Access Compliance Report

Public Rights-of-Way

(Pedestrian Signals)

Intersection ID: N/A	Main Street:	Cross Street: N/A	Location: N/A
ADA ID: 8D8C5A609255	Signal Type: One Push Button-Non APS	Overall Compliance: No	Severity Score: BTN 1: N/A BTN 2: N/A No BTN: N/A
Codes/Mitigation Info/Possible Solution		Field Measurements/Component Compliance

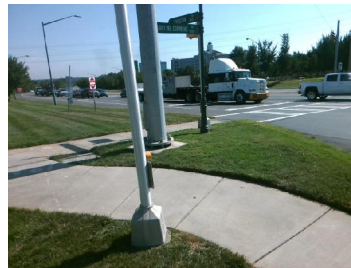
PROW/ADA: TMUTCD 4e.08, R406.2

Possible Solutions: Replace Signal Push Button With APS Button on New Post. Remove & Relocate Sign.
